ADDENDUM NO. 3

**RE: NCDAC NC Correctional Institution for Women
Air Conditioning Installation
SCO ID#: 22-24913-02A
NCDAC Central Engineering Job Order # 4290**

DATE: September 12, 2023

MECHANICAL - DETAILS

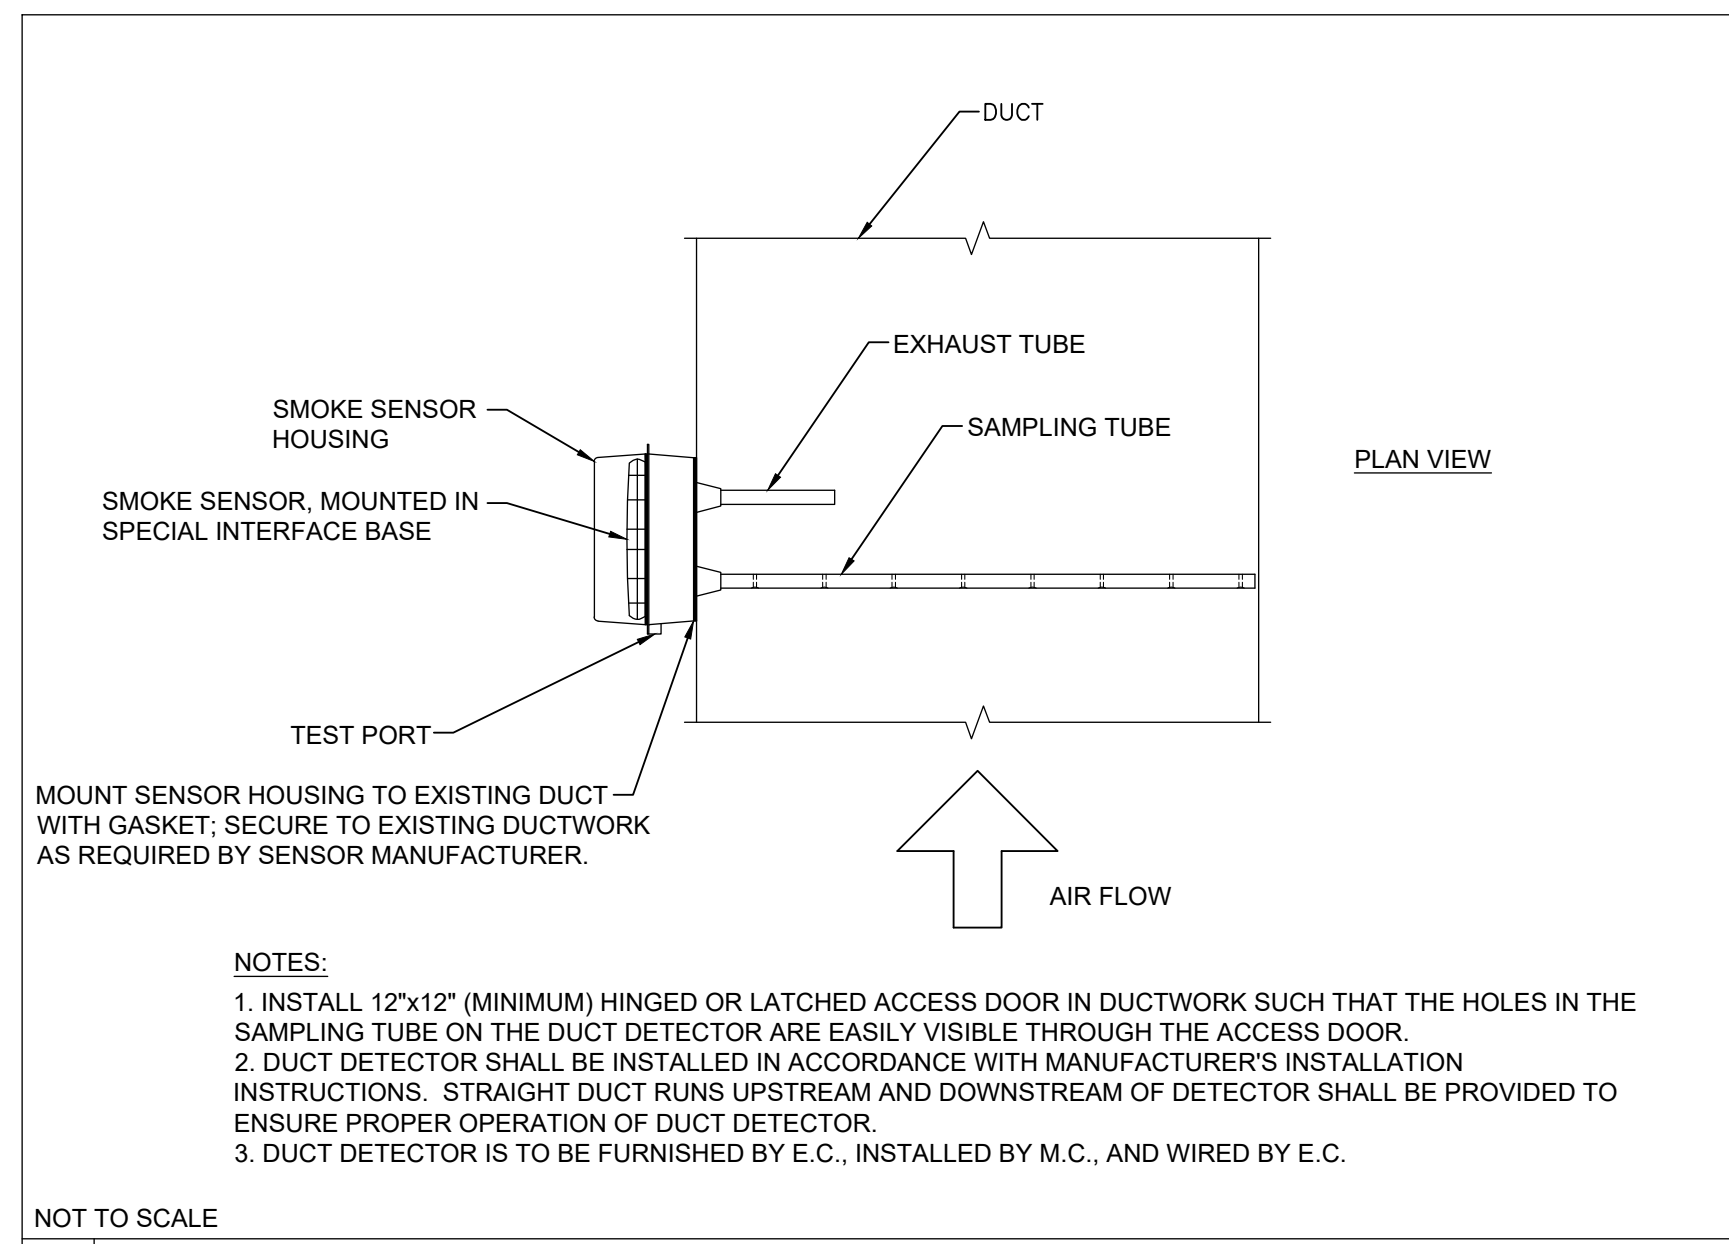
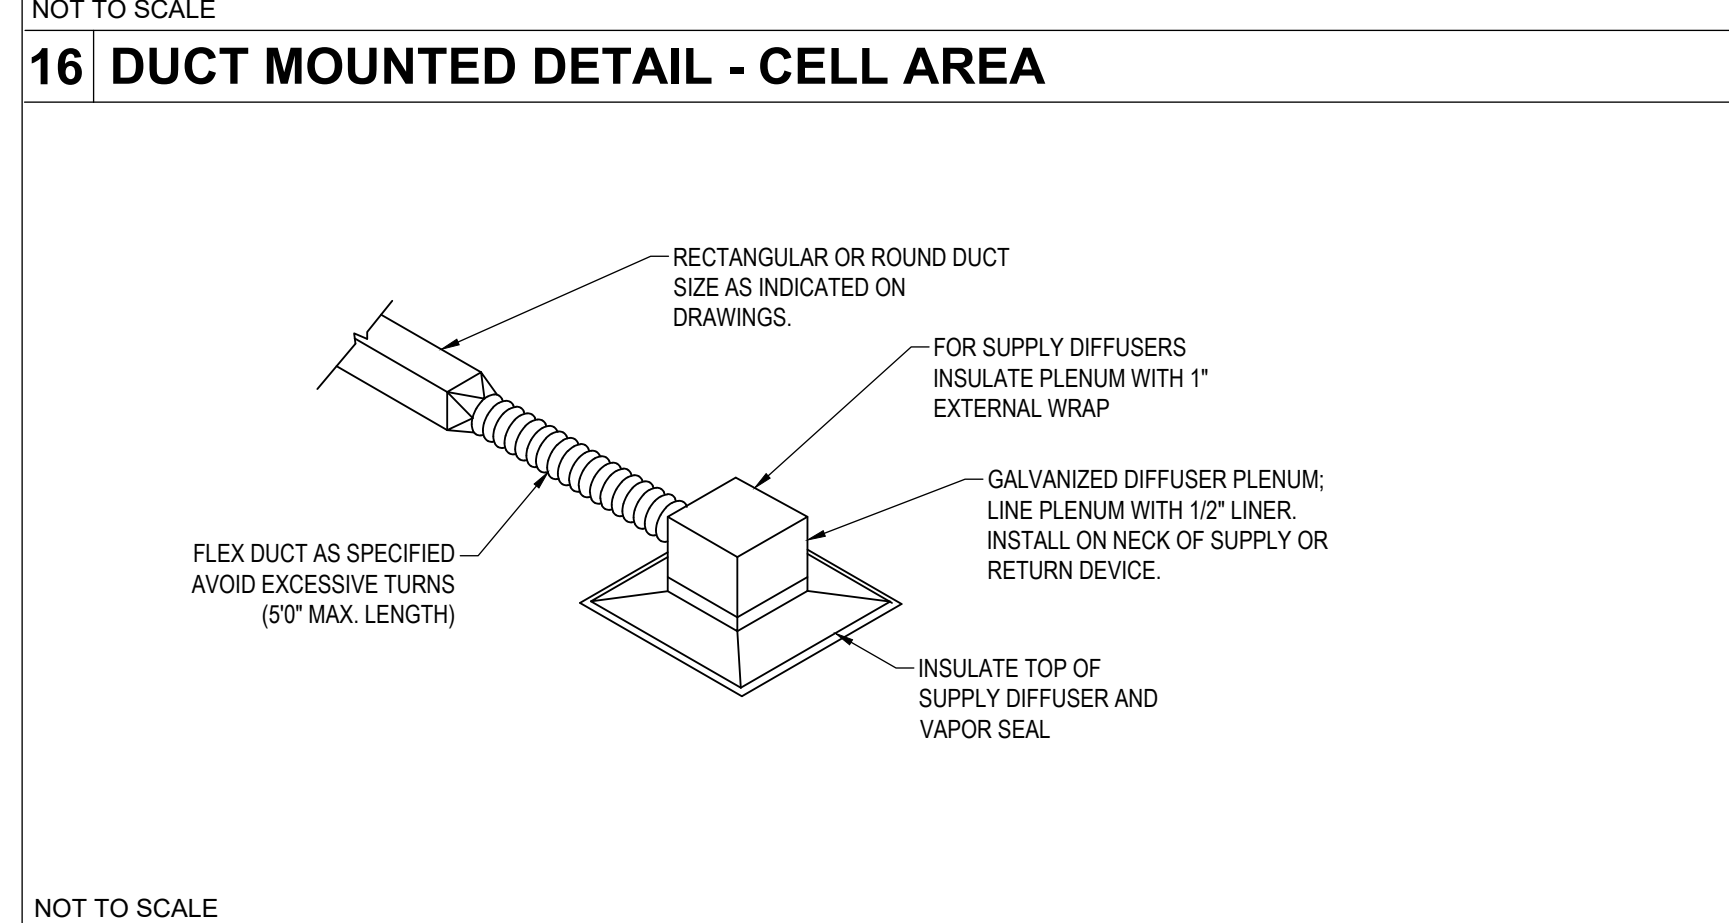
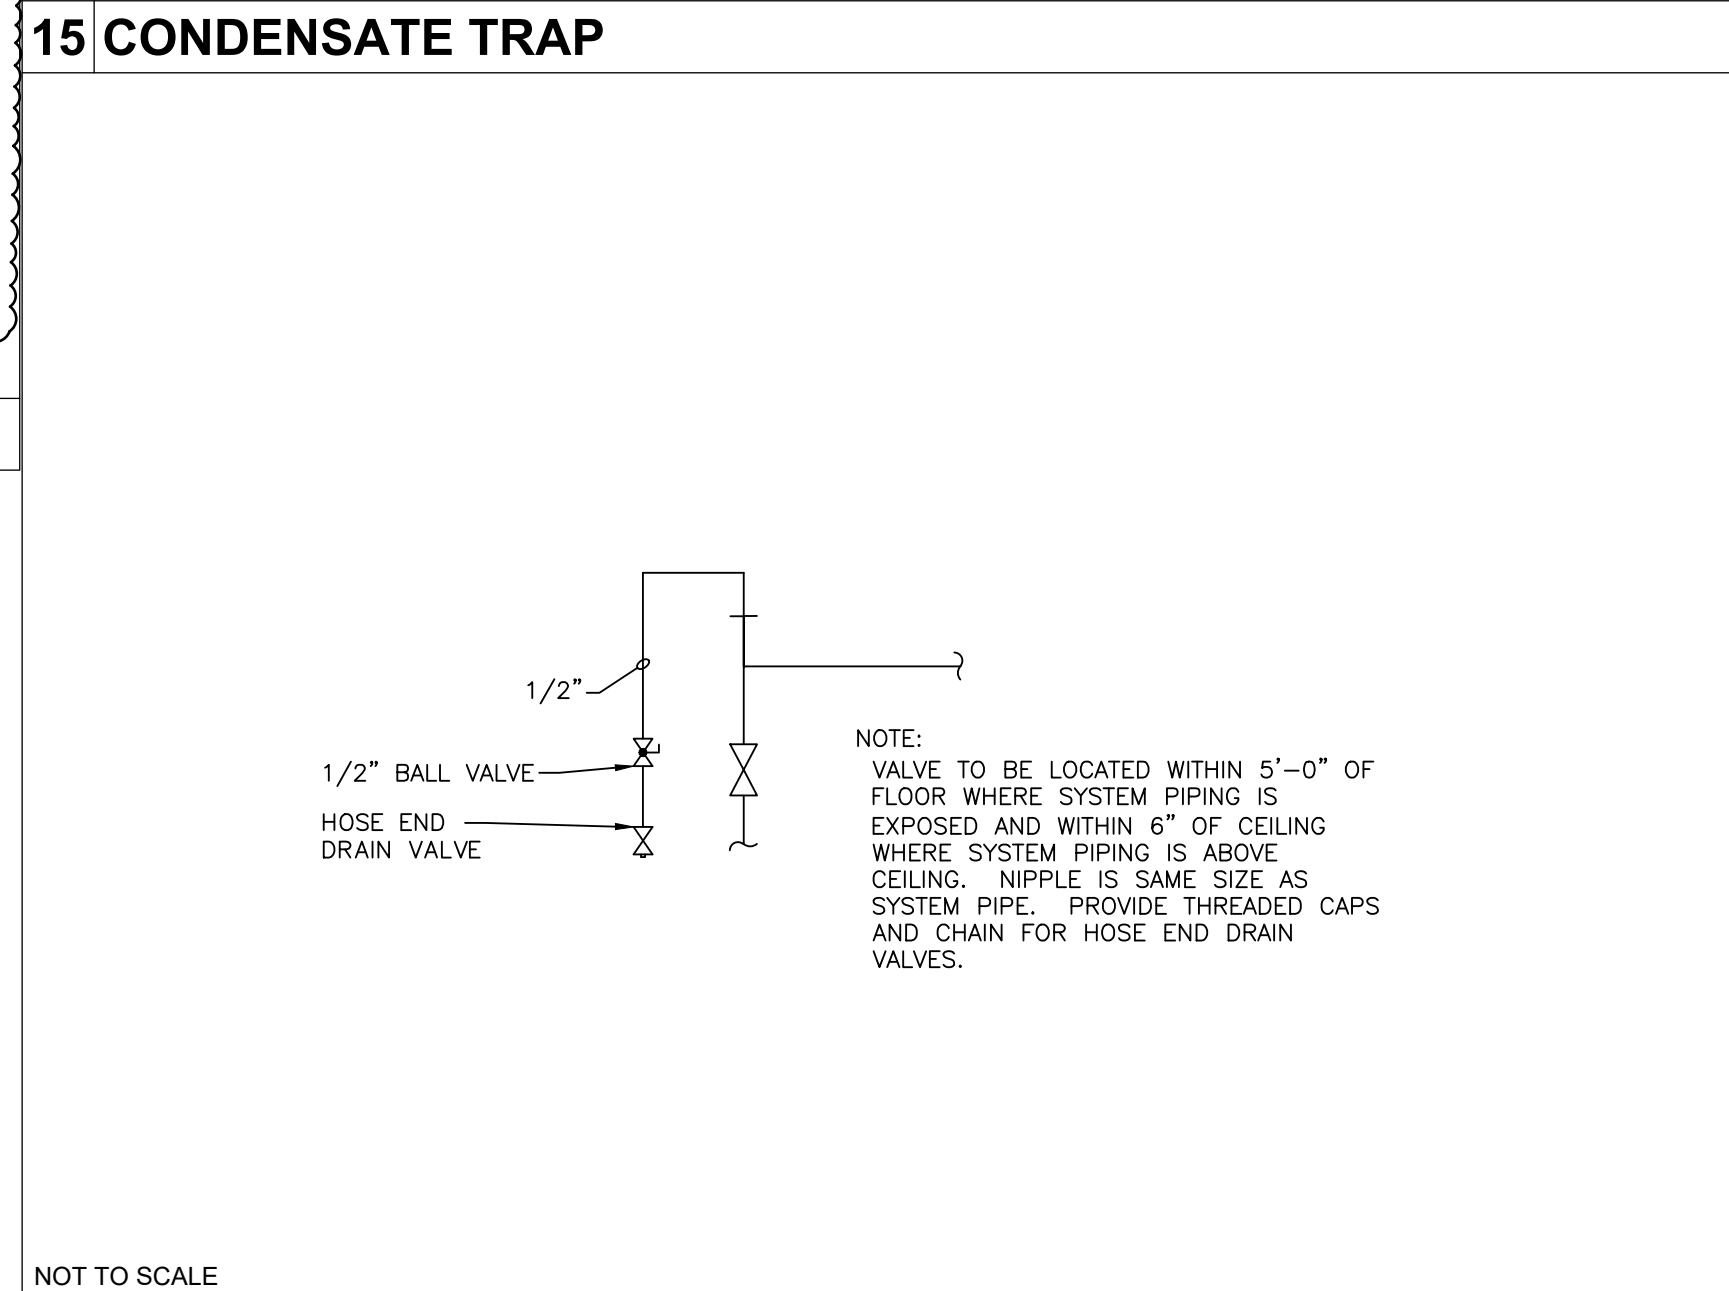
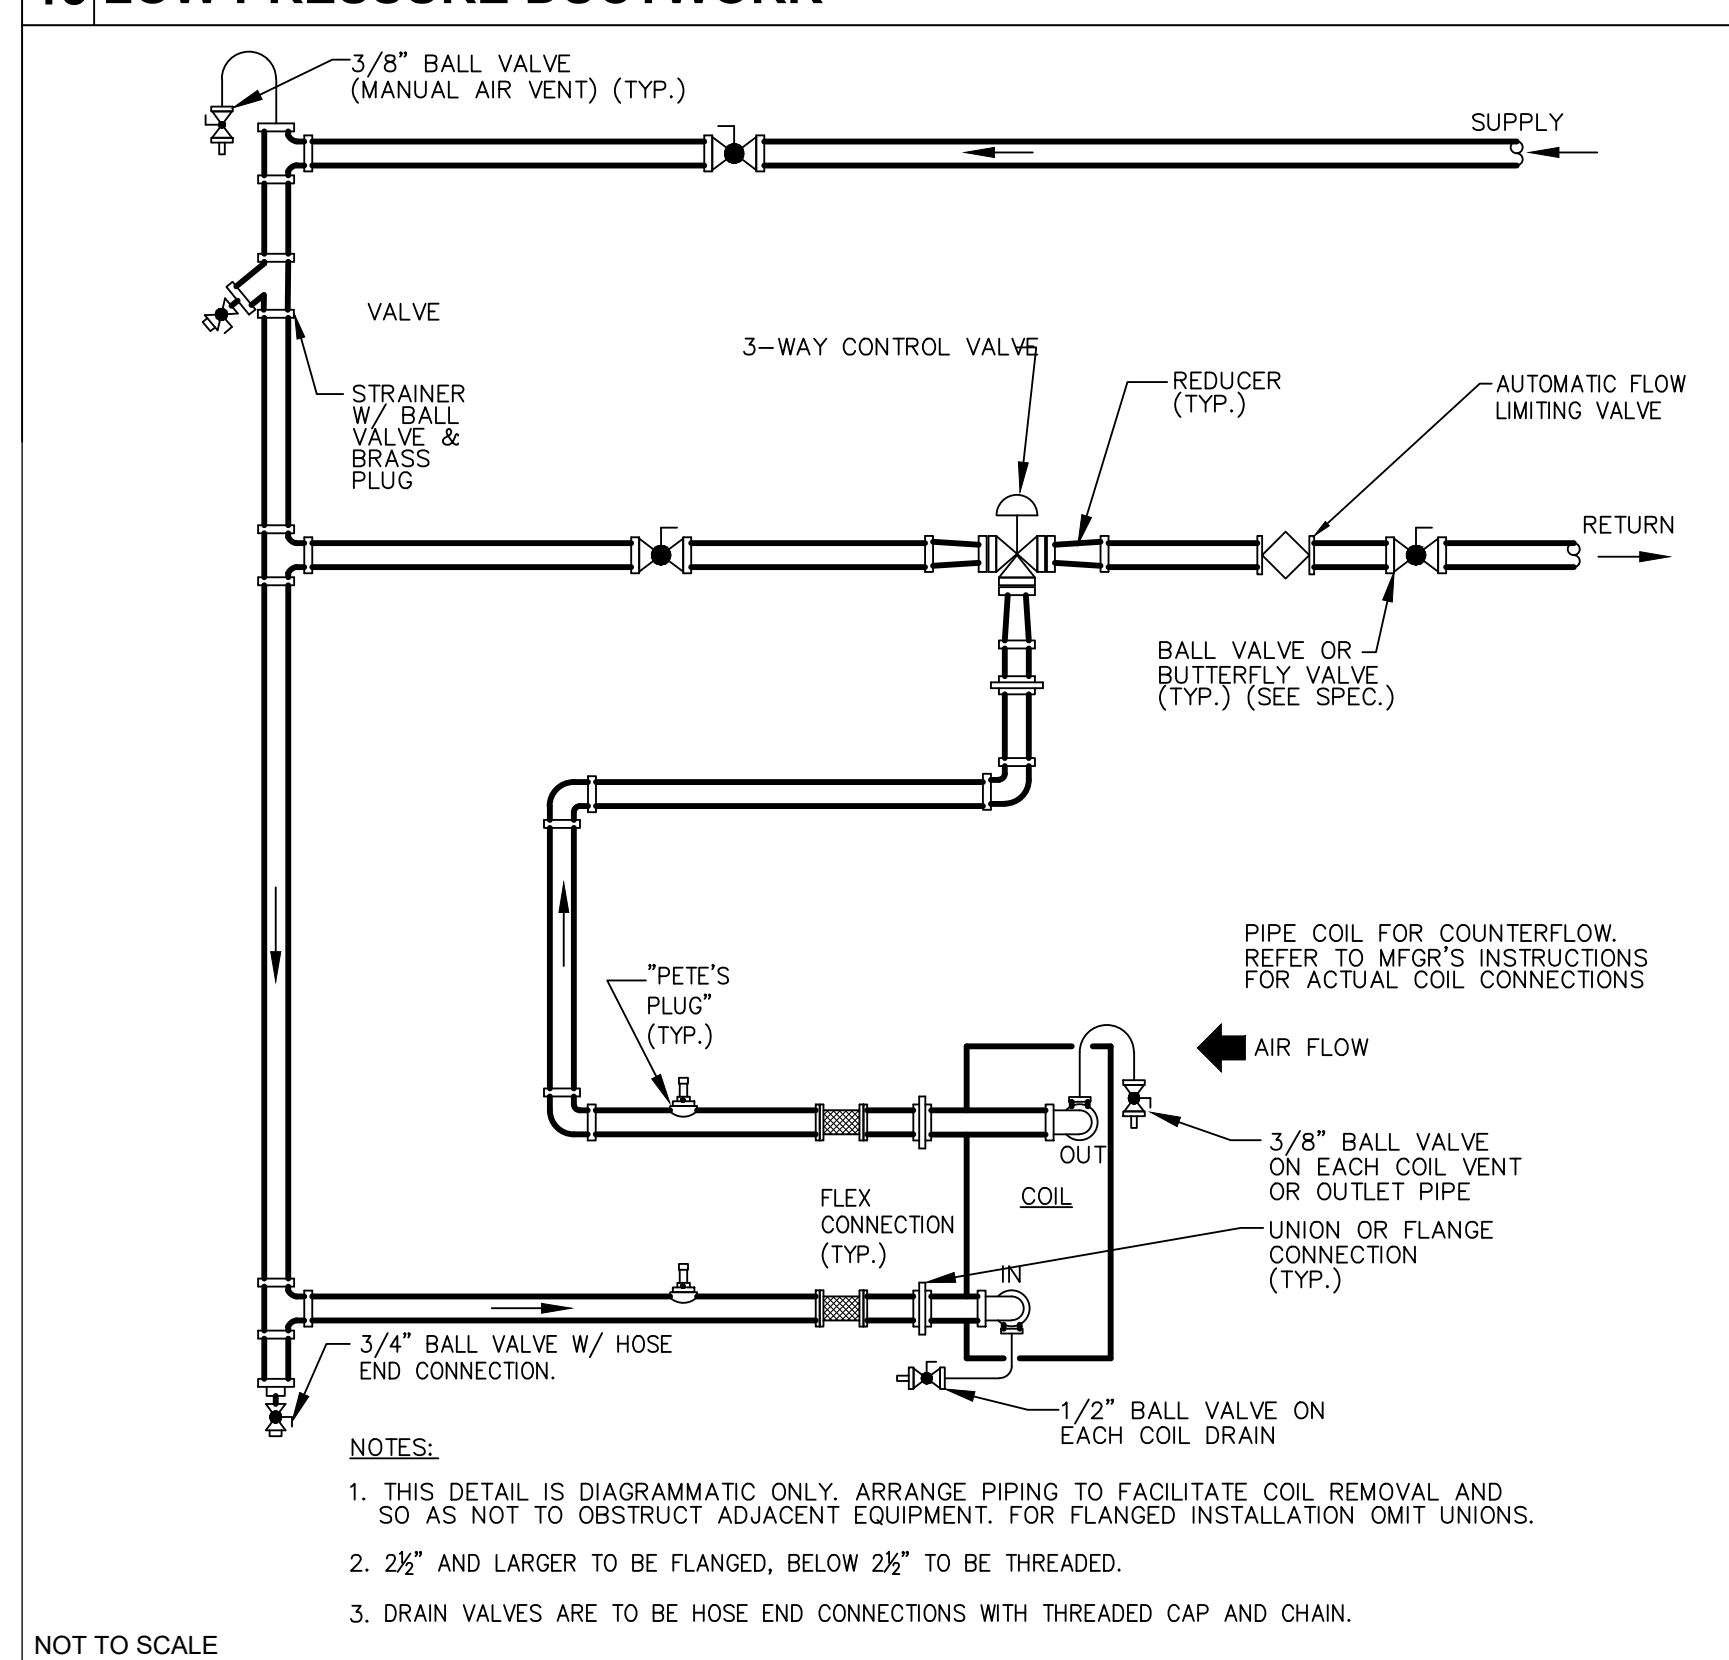
6. Sheet M220: Revised keyed note 1. See revision on attached sheet.
7. Sheet M401: Revised keyed note 6. See revisions on attached sheet.
8. Sheet M501: Revised ductwork detail. Exposed ductwork in dormitories shall be double wall insulated ductwork. See revision on attached sheet.
